Letter of Response

**RE: 35-41 Wilfred Barrett Dr, THE ENTRANCE NORTH NSW 2261
Development Application DA/308/2011**

We refer to the comments from the JRPP meeting dated 17 May 2012. We have since tested a few design options in response to issues raised by the JRPP and we have had a meeting with Wyong Council on 20th June 2012 to discuss the best design outcome. This letter accompanies the revised architectural plans Issue E.

SOLAR ACCESS DIAGRAMS

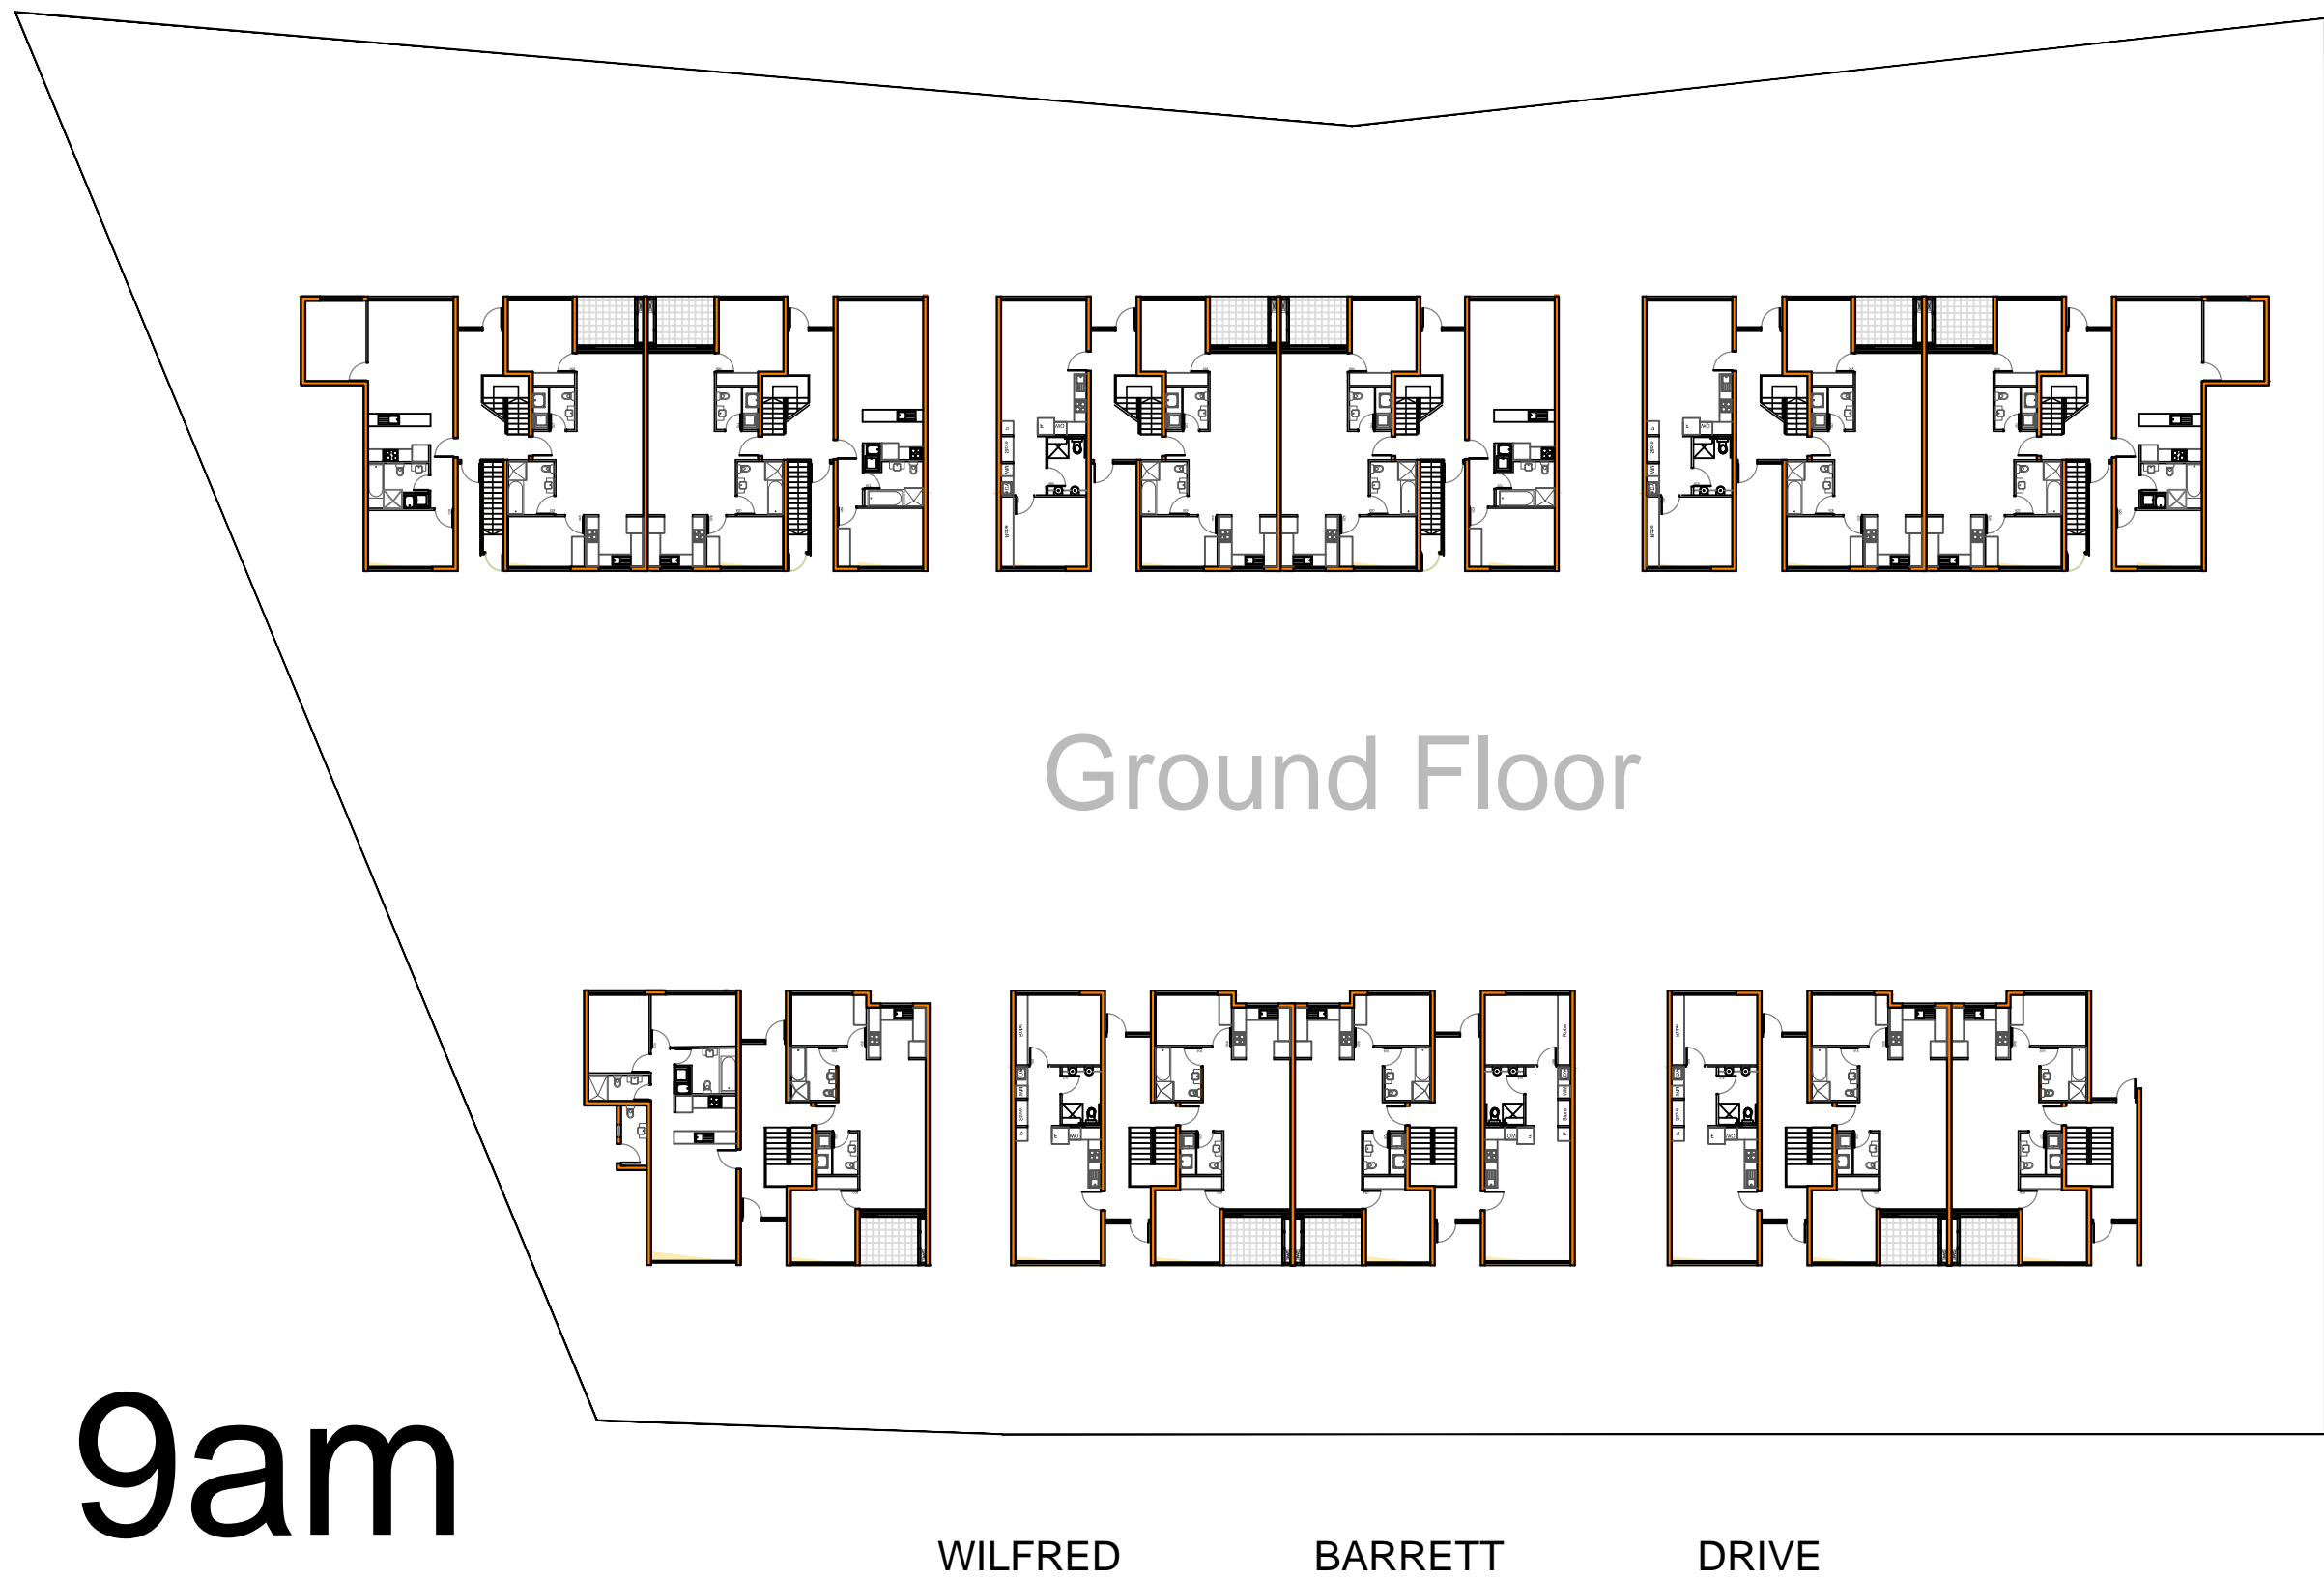
In response to the solar access concern, we have tested 2 alternative design options to increase solar access into units.

Option 2- addition of skylights for all level 1 units. This design option achieves a 79% 3hr solar access into living spaces and private open spaces (exceeding the minimum requirement of 70%). It maintains the initial design proposal of having living spaces and private open spaces of street-front units overlooking the street. By having the living spaces and private open spaces fronting the street will also increase the value of the unit because it is in the aspect of the ocean views. This option not only provides a better amenity, it also enhances passive surveillance to the street (*refer appendix 3 for table of solar access analysis*).

In comparison of the above options, we have concluded that option 2 will be a much better design outcome for the development.
